Merged Document Report

Application No.: PL8504

Plat of Roy Smith Plaza Block 1, Lot 8

**Preliminary Utility Map of
 Roy Smith Plaza
 Block 1, Lot 8**

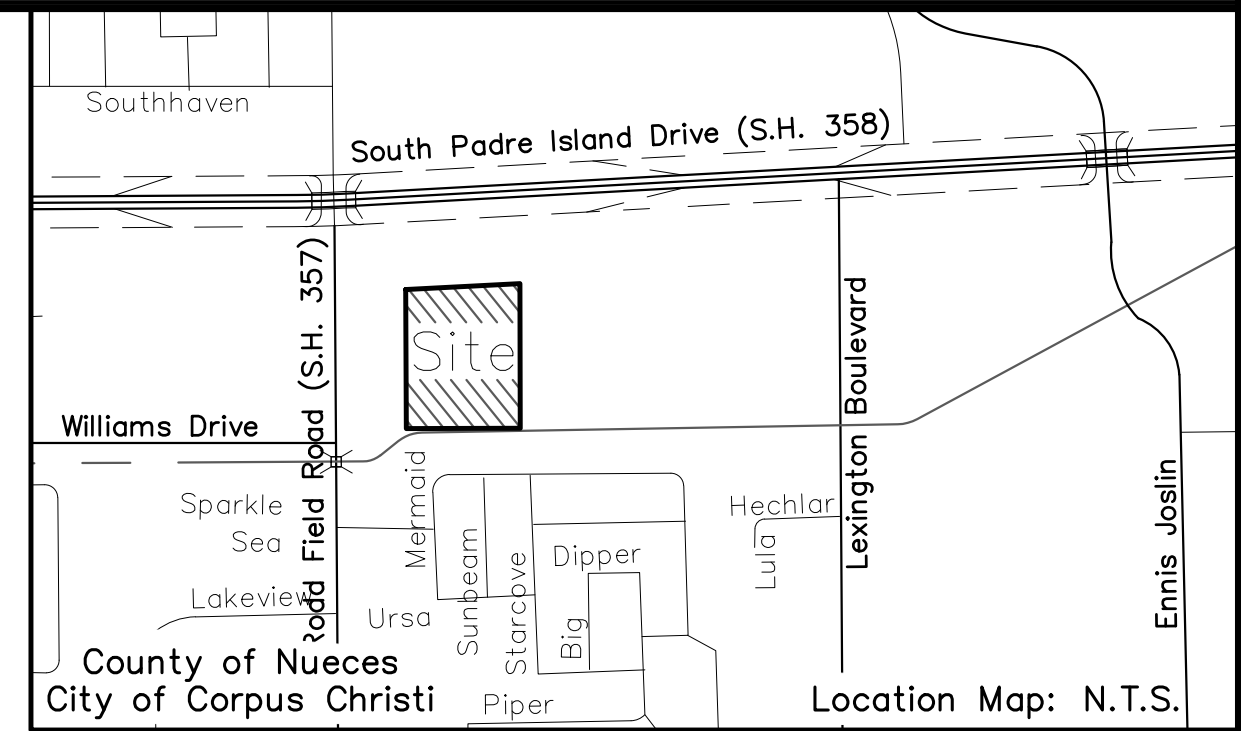
9	P001	Callout	Mark Zans : LD	Open	Remove Al Raymond name. Insert Michael Dice Interim Director	
20	P001	Note	Mark Zans : LD	Open	As of this date (11/1/2024) many of the open comments from the preliminary plat still apply with this plat. Please check the merged document report from preliminary plat application that are open comments.	
8	P002	Note	Mark Zans : LD	Open	Provide doc. numbers for DE, AE, and UE for the easements shown.	
24	P002	Note	Mark Zans : LD	Open	Traffic comments received 11/7/2024: -Plat- The feasibility study is still in progress. the ROW that the applicant will need to dedicate will be between 15' and 130.5' pending on which cross section is selected. this would be north of the 75' drainage ROW.	
12	SWQMP	Callout	Alex Harmon : LD	Open	Remove note 6 and on the plat and SWQMP add the following note: During the development of the site, any increase in stormwater runoff flow rates must be mitigated in accordance with UDC 8.2.8.A, 8.2.8.B, and IDM 3.05 resulting in no adverse impacts between existing conditions and proposed conditions.

Remove Al Raymond name.
Insert Michael
Dimitrakou

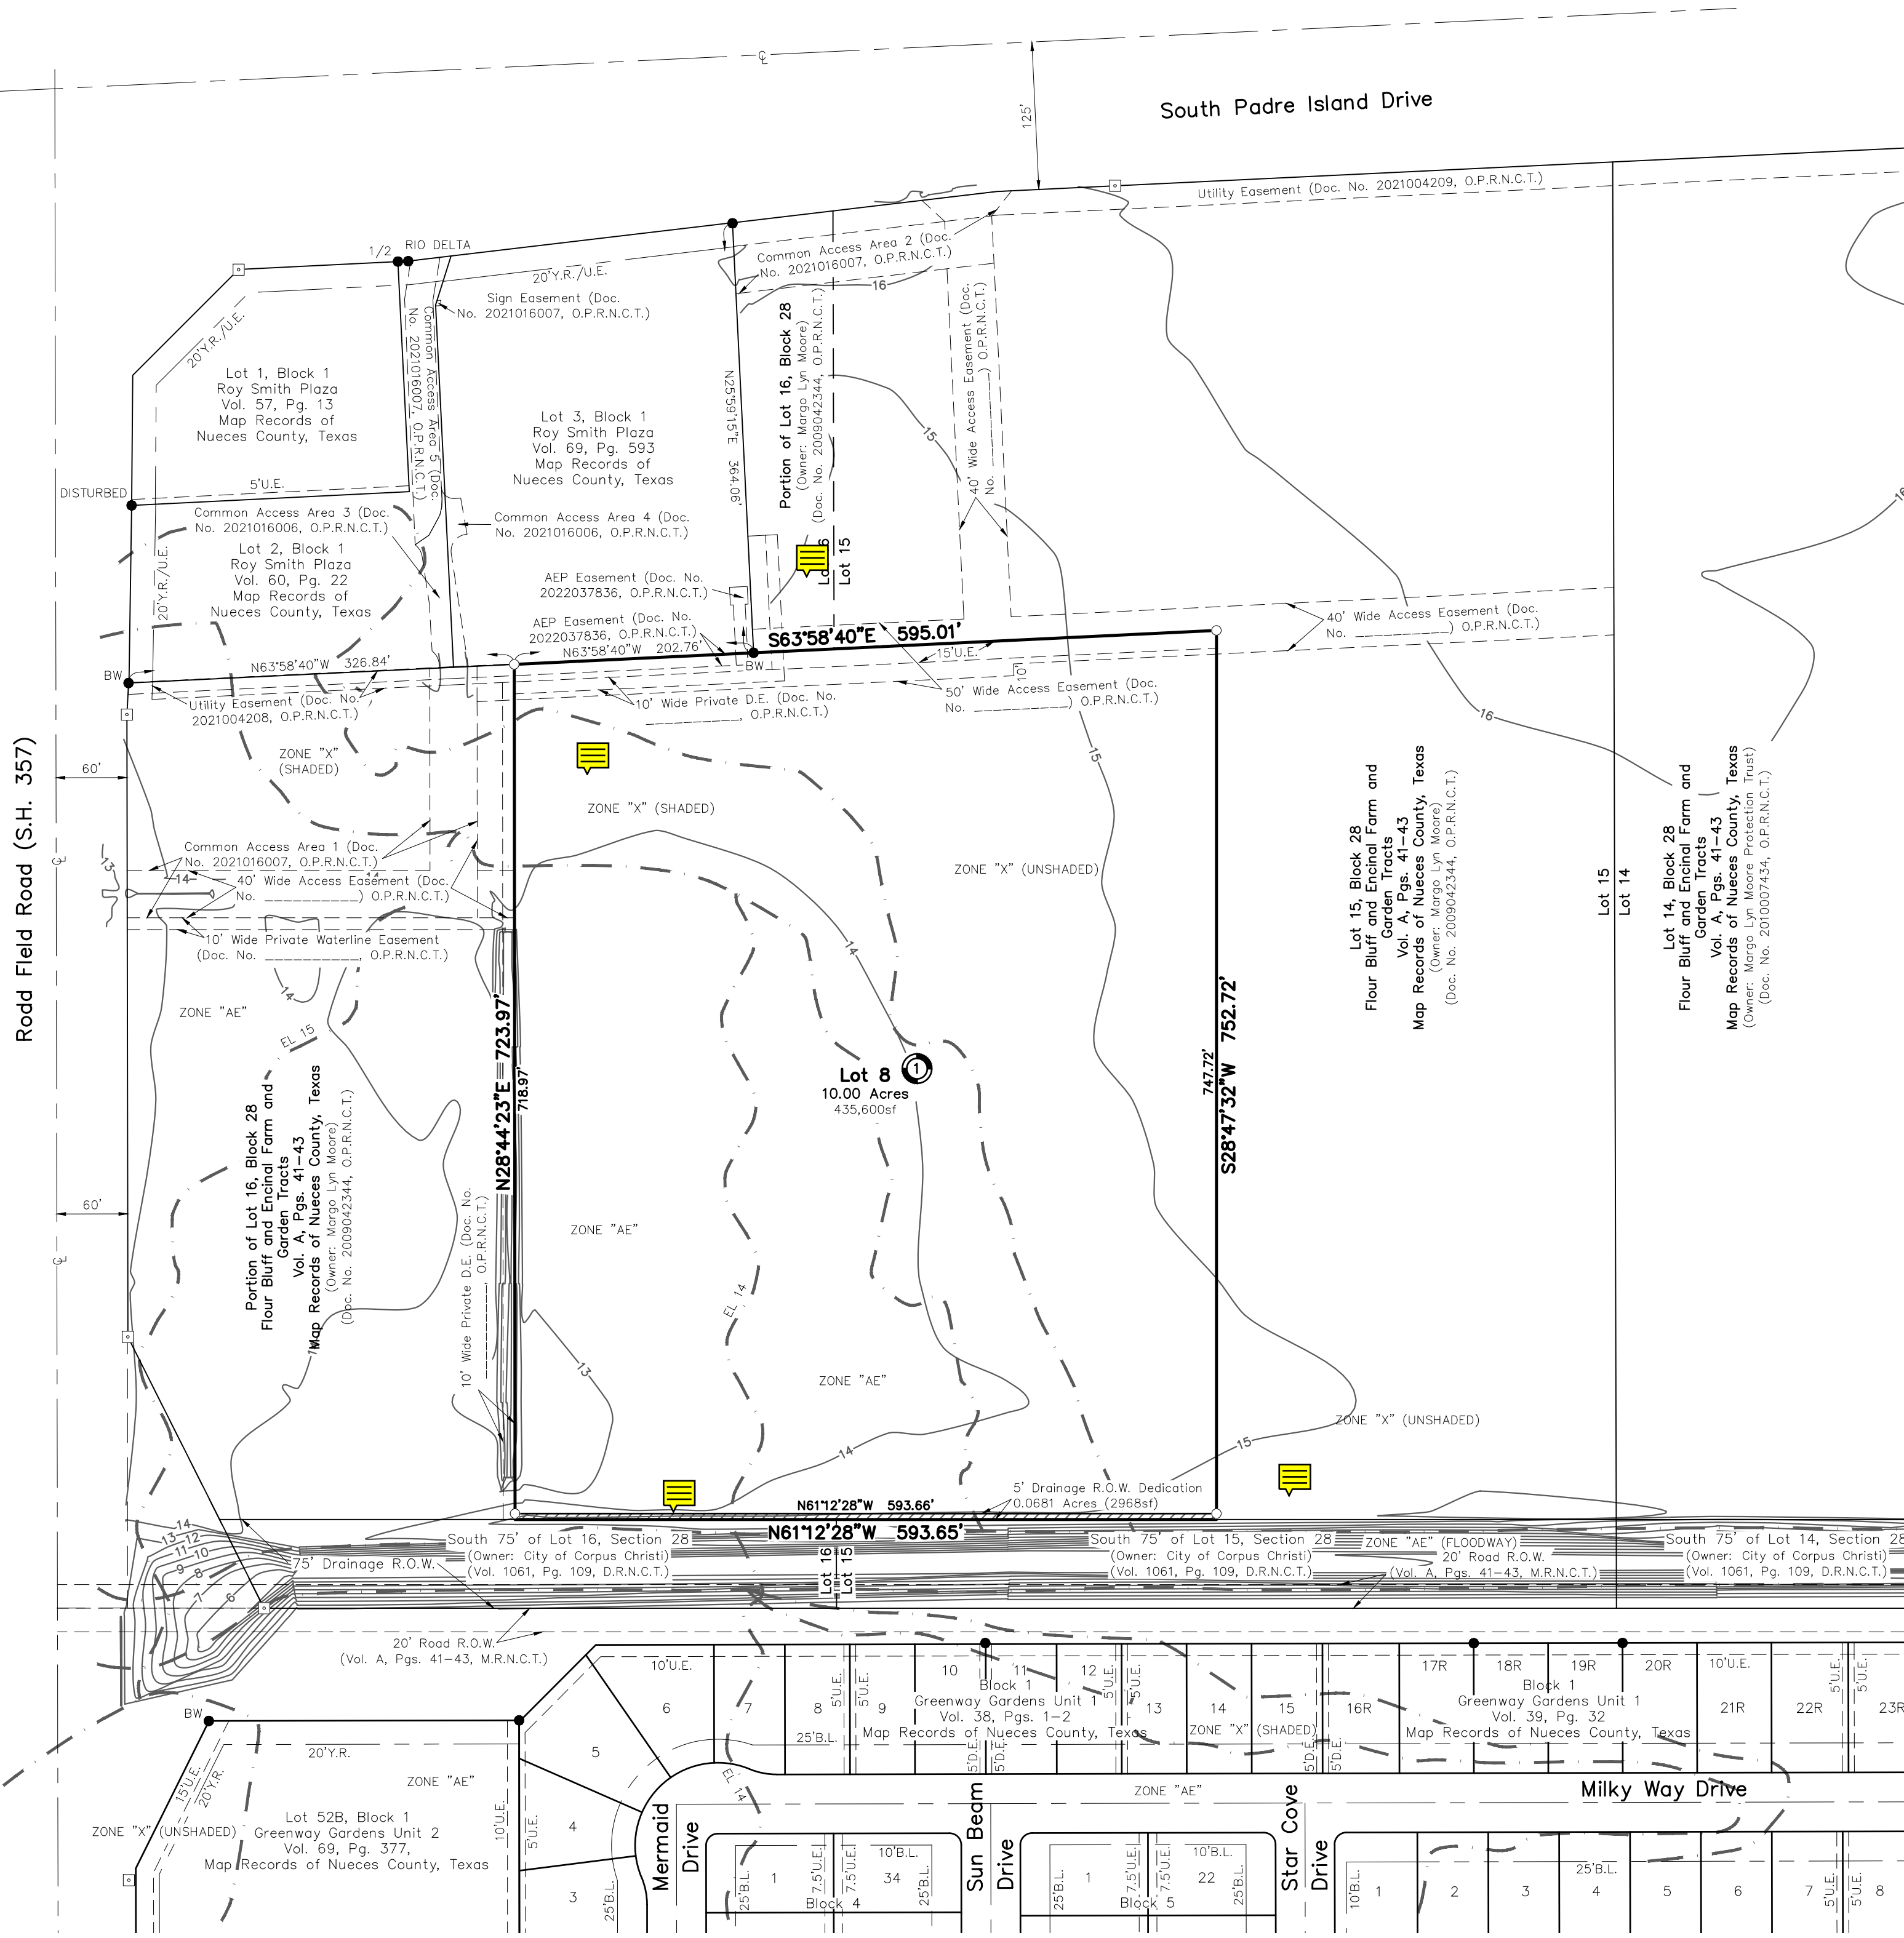
Comment ID	Page Reference	Annotation Type	Author : Department	Status	Review Comments	Applicant Response Comments
21	P001	Note	Melanie Barrera : DS	Open	PW-STW: Add as plat note, not just on SWQMP: During the development of the site, any increase in stormwater runoff flow rates must be mitigated in accordance with UDC 8.2.8.A, 8.2.8.B, and IDM 3.05 resulting in no adverse impacts between existing conditions and proposed conditions.	
11	P002	Note	Alex Harmon : DS	Open	Williams is identified as a Primary Collector (C3) street on the Urban Transportation Plan and is proposed to extend to the south of these lots from Rodd Field to Lexington. Show the typical crosssection for this street. Unless otherwise approved by the City and/or Director of Public Works.	
23	P002	Note	Melanie Barrera : DS	Open	PW-STW: Please confirm storm mitigation efforts will be privately maintained with a plat note.	
16	Utility Map	Note	Alex Harmon : DS	Open	Informational: Approval of a plat does not approve the layout of public utilities, including but not limited to water, wastewater, stormwater, SWQMP, and roadways. These items are only approved via Public Improvement Plans, which are required at time of final plat.

1	P001	Note	Mark Zans : LD	Open	<p>TxDOT comments- Please add the below 4 notes regarding access/drainage onto the state roadway system.</p> <p>•No increase in stormwater discharge to the State right-of-way will be accepted by TxDOT.</p> <p>•TxDOT permits will be issued in accordance with</p>

Comment ID	Page Reference	Annotation Type	Author : Department	Status	Review Comments	Applicant Response Comments
					<p>access management standards and all applicable state and federal laws, including relevant rules and regulations. Considerations will include access connection spacing, materials, geometrics, accessibility, and other design specifications, as well as the impact on drainage and hydraulics, utility location or relocation, and environmental effects resulting from the requested construction of an access connection (43 Tex. Admin. Code § 11.52, 2020).</p> <ul style="list-style-type: none"> •□Drainage improvements must accommodate runoff from the upstream drainage area in its anticipated maximum "build-out" or "fully developed" condition and should be designed to prevent overloading the capacity of the downstream drainage system. •□If the owner responsible for maintaining the permanent stormwater or water quality control fails to maintain it to TxDOT ROW standards, the owner must rectify the issue. •□Any development that anticipates an increase in existing traffic generation may be required to conduct a traffic study. The necessary improvements identified in the traffic study may need to be constructed by the developer, based on TxDOT's discretion and approval, prior to the access connection being established

2	P001	Note	Mark Zans : LD	Open	Plat is a Final plat.	
3	P001	Note	Mark Zans : LD	Open	This plat is on the 30-day tract for approval, approval with Conditions, or disapproval by 11/13/2024. The deadline for revisions to be submitted is 11/4/2024	
4	P001	Note	Mark Zans : LD	Open	The plat will be recommended as Conditional Approval for Resolution comments received and that have remained Open and unmet.	
5	P001	Note	Mark Zans : LD	Open	A request or response may be made for an additional 30 days for Public Notice plat with a Waiver or to resolve Open comments. This request must be made directly to Development Services within the 30-day initial period.	
6	P001	Note	Mark Zans : LD	Open	<p>Fire comments 1-9:</p> <p>1□Plat□Note: All code reference is based on currently adopted International Fire Code (IFC) 2021 and Corpus Christi Water Distribution Standards.</p> <p>2□Plat□"Commercial Development shall have a fire flow of 1,500 GPM with 20 psi residual Fire hydrant every 300 feet and operational."</p>

Comment ID	Page Reference	Annotation Type	Author : Department	Status	Review Comments	Applicant Response Comments
					<p>3 Plat 507.5.1 (amendment) Where Required: All premises, other than one-family detached dwellings, where buildings or portions of buildings are located more than 150 feet from a fire hydrant shall be provided with approved on-site hydrants and water mains capable of supplying the fire flow require by the fire official. The minimum arrangement being so as to have a hydrant available for distribution of hose to any portion of building on the premises at distances not exceeding 300 feet. Exception: For buildings equipped with an approved automatic sprinkler system, the distance requirement shall be 500 feet.</p> <p>4 Plat 507.5.4 Obstruction. Unobstructed access to fire hydrants shall be maintained at all times. The fire department shall not be deterred or hindered from gaining immediate access to fire protection equipment or fire hydrants. Note: Hose lay from a hydrant will not cross an arterial street.</p> <p>5 Plat 912.2.3 (amendment) Proximity to Hydrant: Fire department connections (FDC) for each sprinkler system or standpipe system shall be located not more than 100 feet from the nearest fire hydrant connected to an approved water</p> <p>6 Plat 503.1.1 (amendment) Buildings and facilities: Approved fire apparatus access roads shall be provided for every facility, building, or portion of a building hereafter constructed or moved into or within the jurisdiction. The fire apparatus access road shall allow access to three (3) sides of buildings in excess of fifteen thousand (15,000) square feet and all sides for buildings in excess of thirty thousand (30,000) square feet.</p> <p>7 Plat 3310.1 Required access. Approved vehicle access for firefighting shall be provided to all construction or demolition sites. Vehicle access shall be provided to within 100 feet of temporary or permanent fire department connections. Vehicle access shall be provided by either temporary or permanent roads, capable of supporting vehicle loading under all weather conditions. Vehicle access shall be maintained until permanent fire apparatus access roads are available.</p> <p>8 Plat D102.1 Access and loading. Facilities, buildings, or portions of buildings hereafter constructed shall be accessible to fire department apparatus by way of an approved fire apparatus access road with an asphalt, concrete or other approved driving surface capable of supporting the</p>

Comment ID	Page Reference	Annotation Type	Author : Department	Status	Review Comments	Applicant Response Comments
					<p>imposed load of fire apparatus weighing at least 75,000 pounds.</p> <p>9 Plat 503.1.1 (amendment) Buildings and facilities: During construction, when combustibles are brought on to the site in such quantities as deemed hazardous by the fire official, access roads and a suitable temporary supply of water acceptable the fire department shall be provided and maintained.</p>	
7	P001	Note	Mark Zans : LD	Open	<p>Fire comments 10-18</p> <p>10 Plat 503.2.1 Dimensions. Fire apparatus access roads shall have an unobstructed width of not less than 20 feet, exclusive of shoulders and an unobstructed vertical clearance of not less than 13 feet 6 inches.</p> <p>11 Plat D103.1 Access road width with a hydrant. Where a fire hydrant is located on a fire apparatus access road, the minimum road width shall be 26 feet, exclusive of shoulders.</p> <p>12 Plat "The minimum required width of 20 feet that shall be maintained means a clear unobstructed path that allows the passage of fire apparatus.</p> <p>1. Where Fire Apparatus Access is constructed to the minimum of 20 feet, no parking is allowed within the fire apparatus lane.</p> <p>2. Where a fire hydrant is located on the street, the minimum unobstructed clearance shall be 26 feet. In this instance, no parking is allowed on one side of the street.</p> <p>3. The minimum UDC residential street width is 28 ft. curb to curb. Any parking along the street that reduces the width to less than 20 ft. is prohibited and the Fire Code Official and will require painting "NO PARKING-FIRE LANE" along one side of the street."</p> <p>13 Infor. "Note: Calculated Turning Radii for Fire Apparatus: Inside Turn: 20 ft. 3 in. Curb to curb: 36 ft. 8 in. Wall to wall: 44 ft. 8 in."</p> <p>14 Plat 503.4 Obstruction of fire apparatus access roads. Fire apparatus access roads shall not be obstructed in any manner, including the parking of vehicles. The minimum widths and clearances established in sections D103 shall always be maintained.</p>

Comment ID	Page Reference	Annotation Type	Author : Department	Status	Review Comments	Applicant Response Comments
					<p>15 Plat 503.3 Marking: Where required by the fire code official, approved signs, or other approved notices the include the words NO PARKING-FIRE LANE shall be provided for fire apparatus access roads to identify such roads to prohibit the obstruction thereof. The designation of a fire lane can be marked with conspicuous signs which have the words:" Fire Lane-No Parking" at 50-foot intervals. In lieu of signs, fire lanes may be marked along curbing with the wording, "Fire Lane-No Parking" at 15-foot intervals.</p> <p>16 Plat Table D103.4 Requirements for Dead-end fire apparatus access roads. Turnaround provisions shall be provided with a 96-foot diameter cul-de-sac.</p> <p>17 Plat 503.2.5 Dead ends. Dead-end fire apparatus access roads more than 150 feet in length shall be provided with an approved area for turning around fire apparatus.</p> <p>18 Plat Commercial development of the property will require further Development Services review.</p>
